Project Name: *

I-40 from I-440/US 64 (Exit 301) to just north of SR 1525 (Cornwallis Road)

Subject: **Modification Request for Section 404 Individual Permit, Section 401 Water Quality Certification and Neuse Riparian Buffer Authorization** for Interstate 40 Widening and Improvements from I-440/US 64 (Exit 301) to just north of SR 1525 (Cornwallis Road), including improvements to NC 42 and SR 1010 (Cleveland Road) in Wake and Johnston Counties, Federal Aid Project No. IMNHF-040-4(139)301; TIP Numbers I-5111 and I-4739, Division 5. Debit \$570 from WBS Element 42346.3.1.

c:\pw-work\rsh-pw\pw-user\d0228771\I511-I4739_hyd-buf_8_psh08.dgn

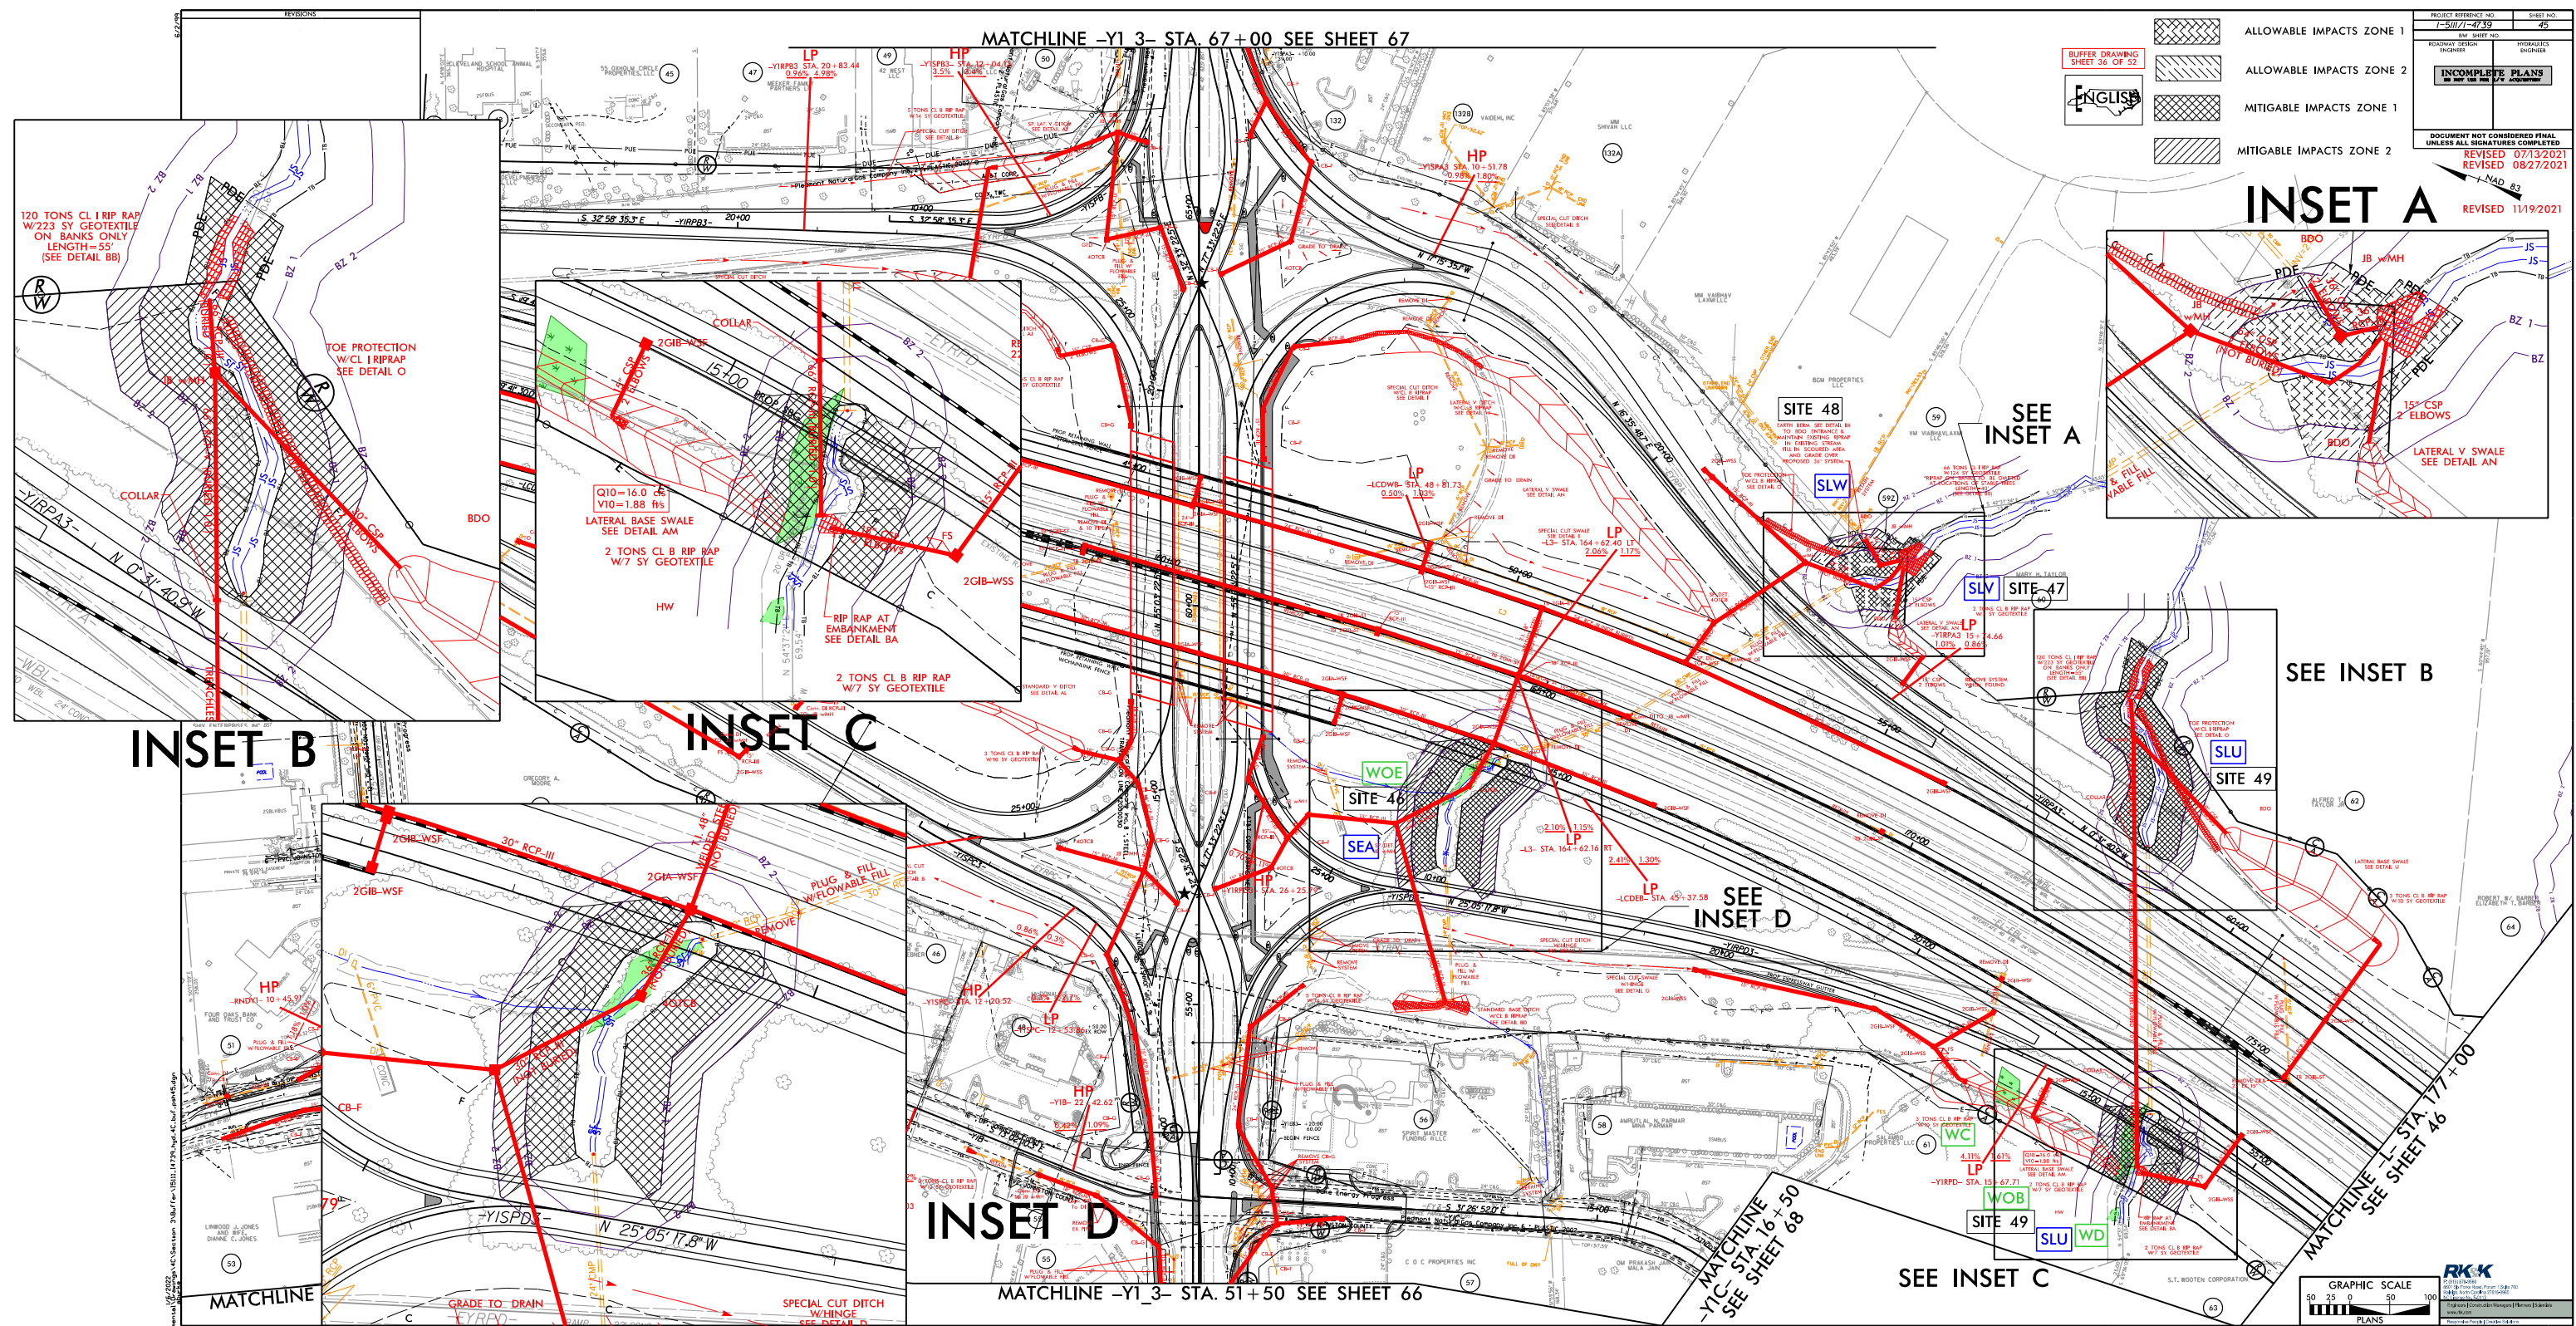
Site 4: Noise wall installation required a stormwater drainage system shift beyond the cut/fill line and outside of the noise wall (Plan Sheet 7), which resulted in moving the noise wall further to the east (Plan Sheet 8). Therefore, additional buffer impacts are proposed.

- Buffer Drawing 7: plan sheet 7
- Buffer Drawing 8: plan sheet 8
- Buffer Drawing 45: buffer summary table
